**TOWN OF GRANITE QUARRY
PLANNING BOARD
REGULAR MEETING AGENDA
March 6, 2023
6:00 p.m.**

Subject: CD-PUD (Conditional District-Planned Unit Development)
Case #: ZO-23-02
Project Address: TBA N Salisbury Ave./Stokes Ferry Rd.
Project Tax Parcel#: 066 047
Property Owners: Florence Sifford Heirs
Applicant: Belle Realty Development Inc. (Wallace Realty)
Current Zoning: RL (Residential Low Density) & OI (Office & Institutional)
Action Date: Planning Board- March 6th, 2023
Request: Rezone from RL & OI to CD-PUD with Site Plan

SIFFORD RESIDENTIAL SUBDIVISION

Project Name: "Sifford" PUD Subdivision **Revision**

AMENITY CENTER ELEVATIONS

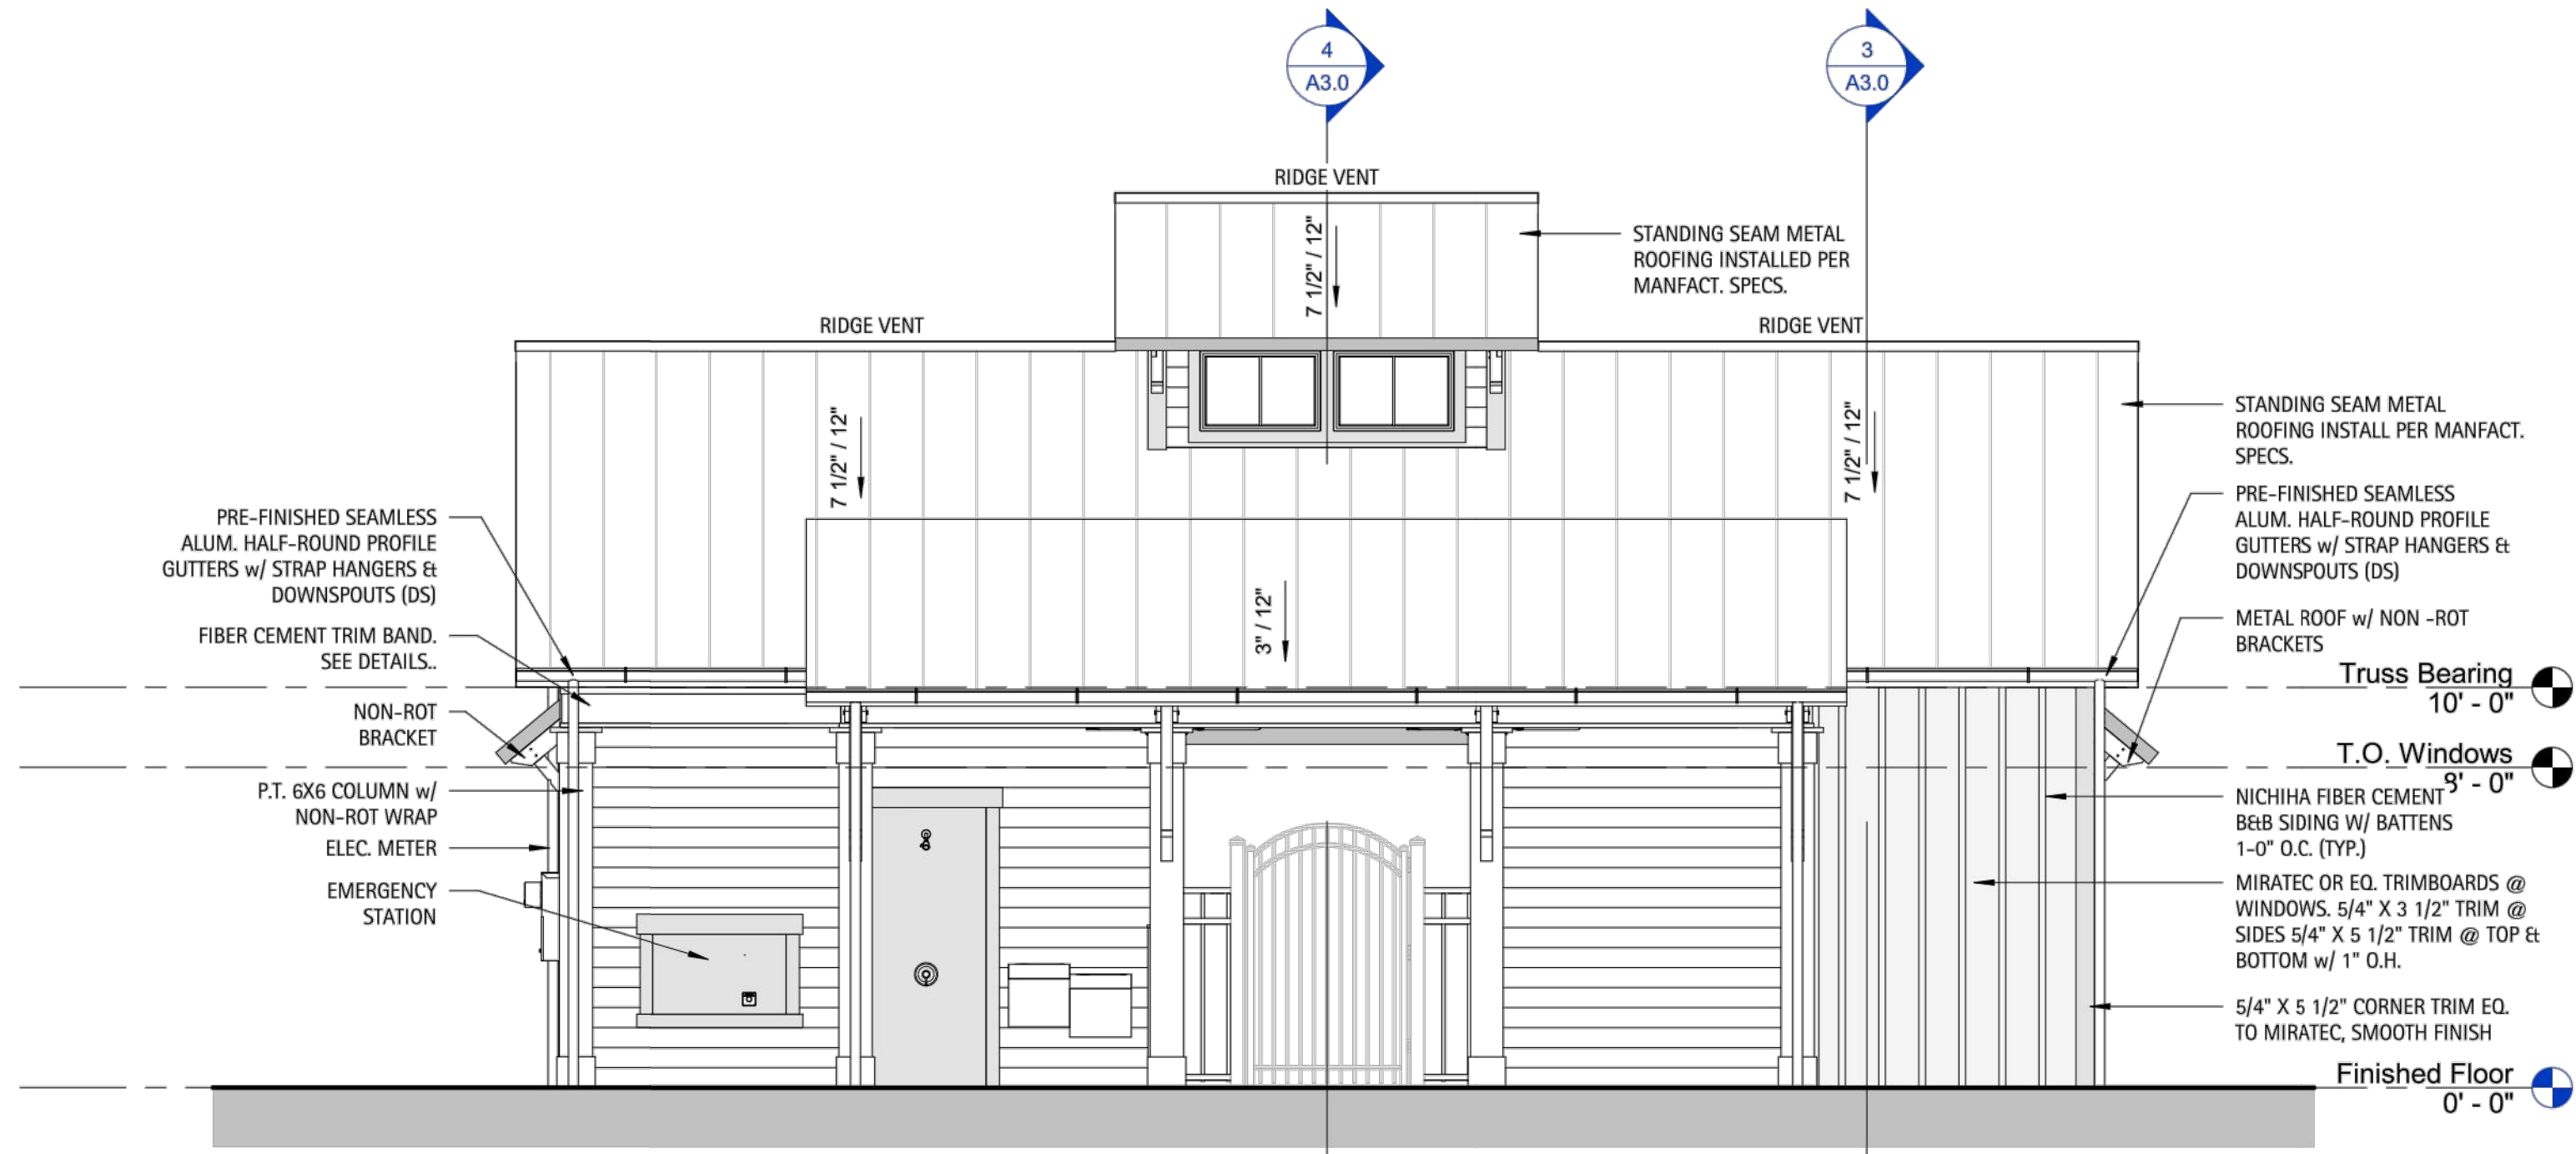
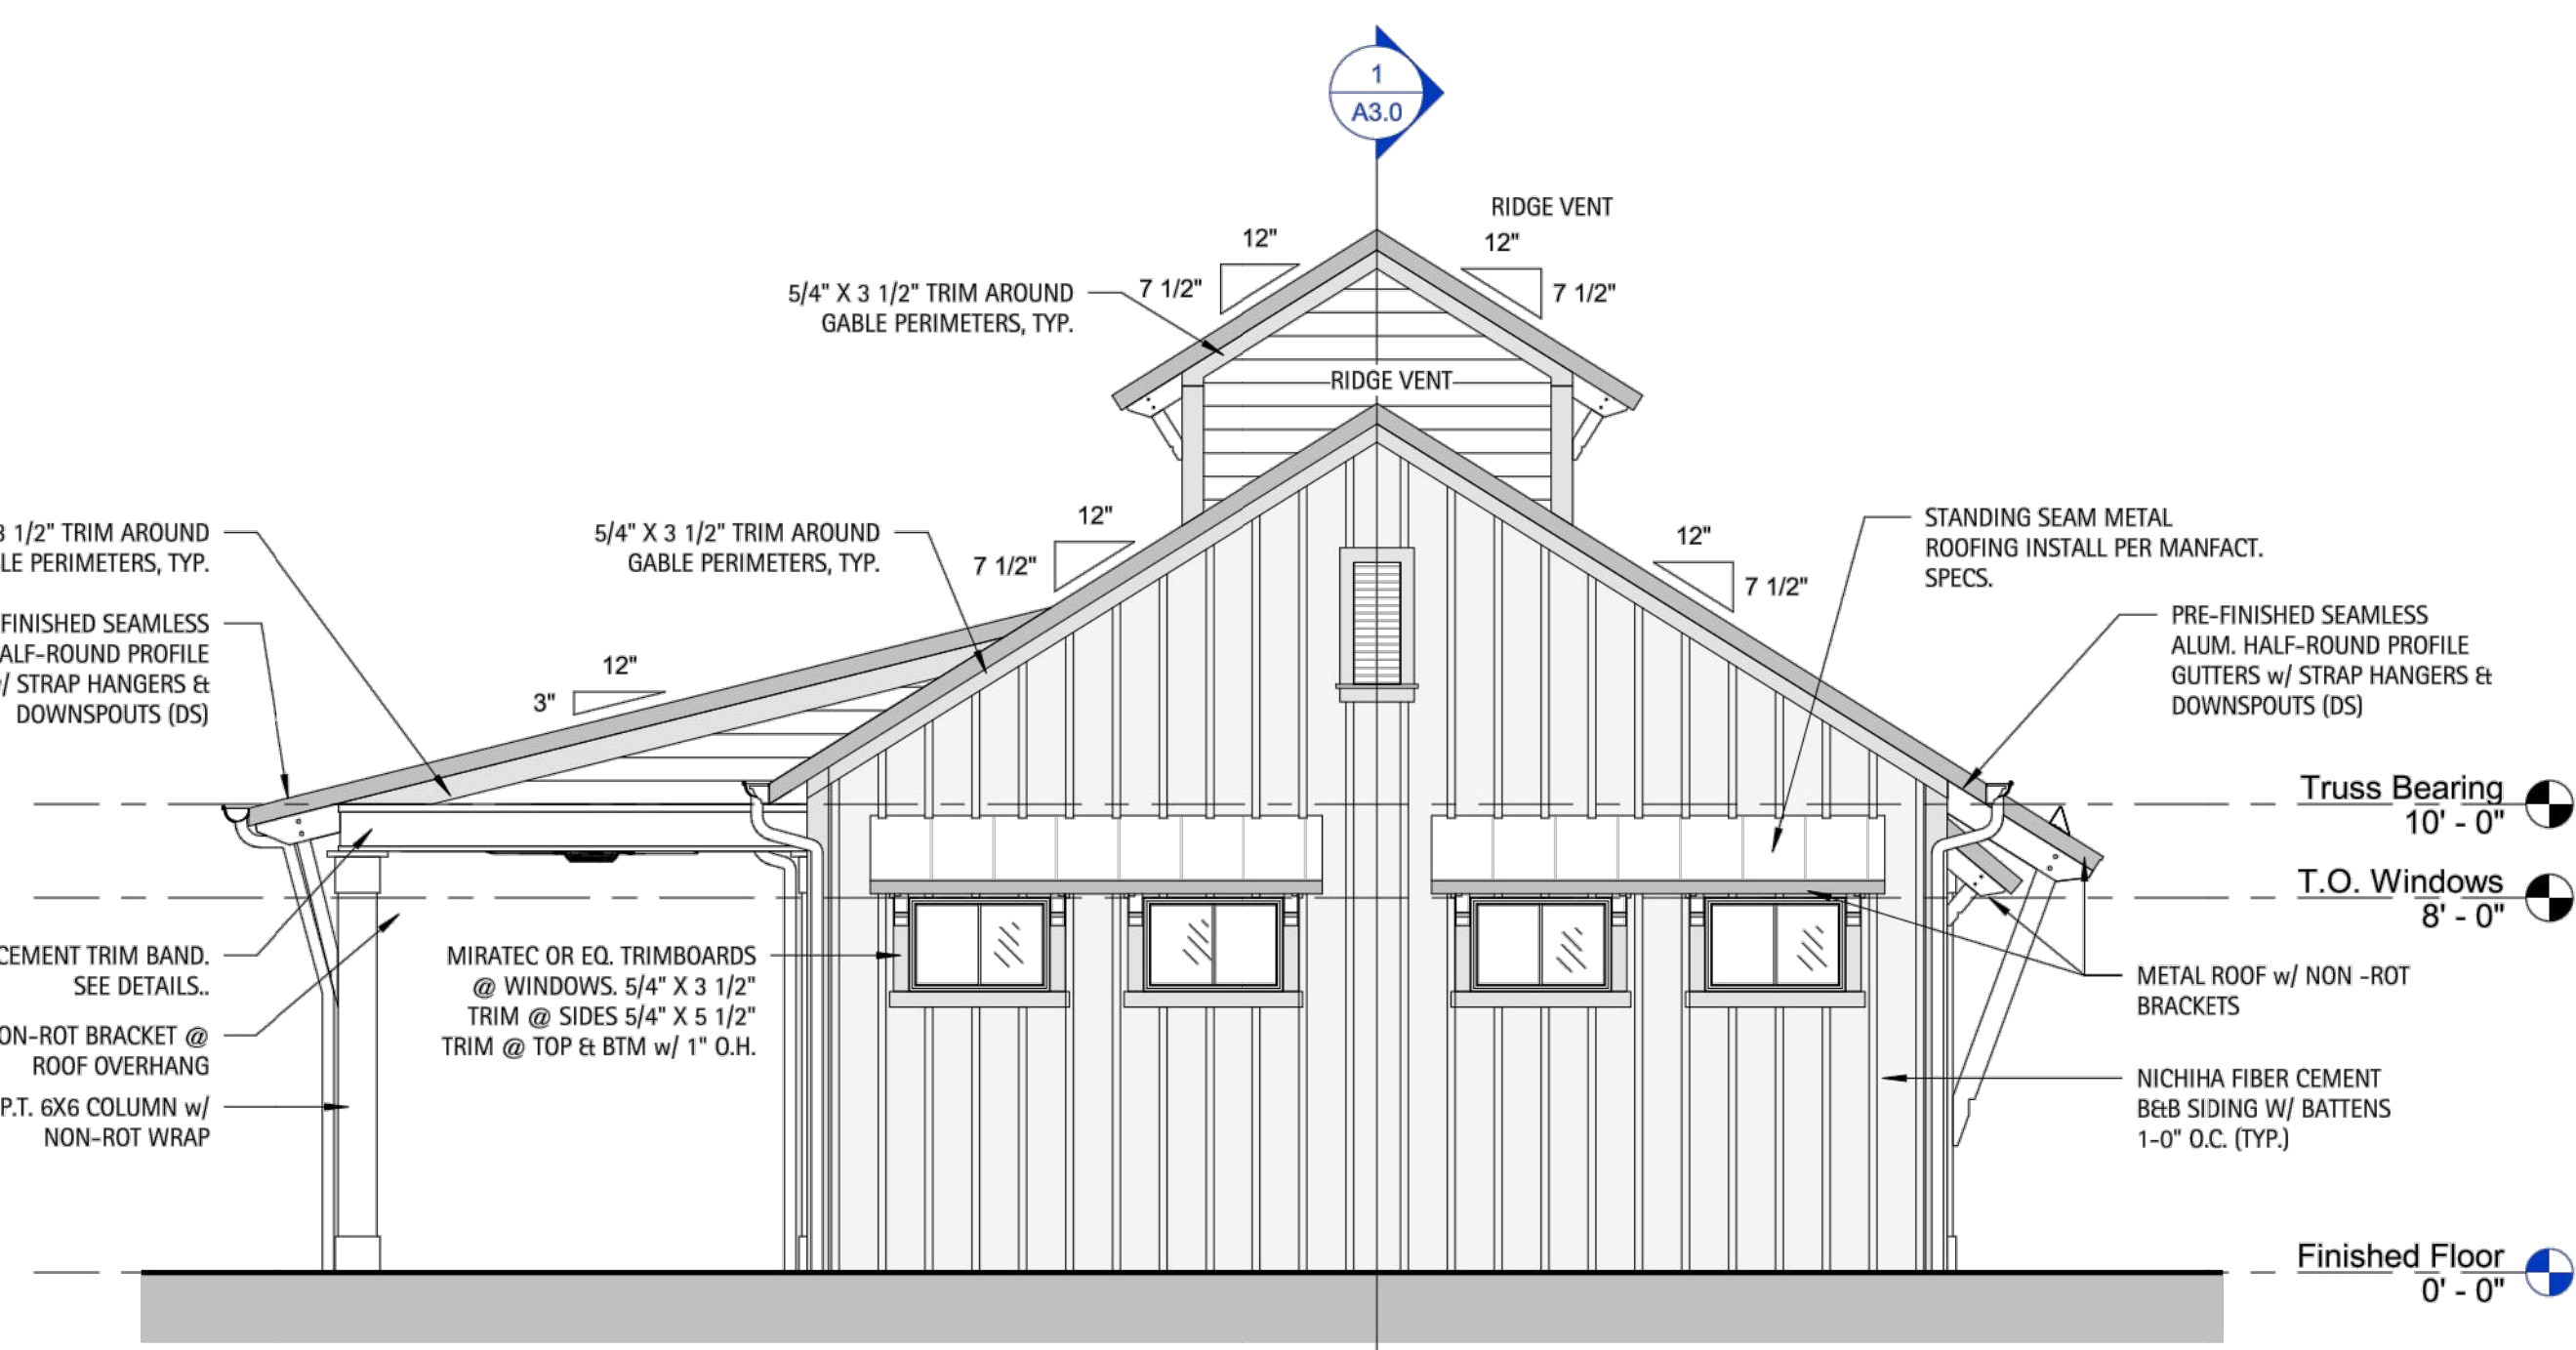
- Would prefer to see amenities center more centrally located or add additional amenities area in Phase III
- Pool is mentioned at amenities center but no location shown unless indoors
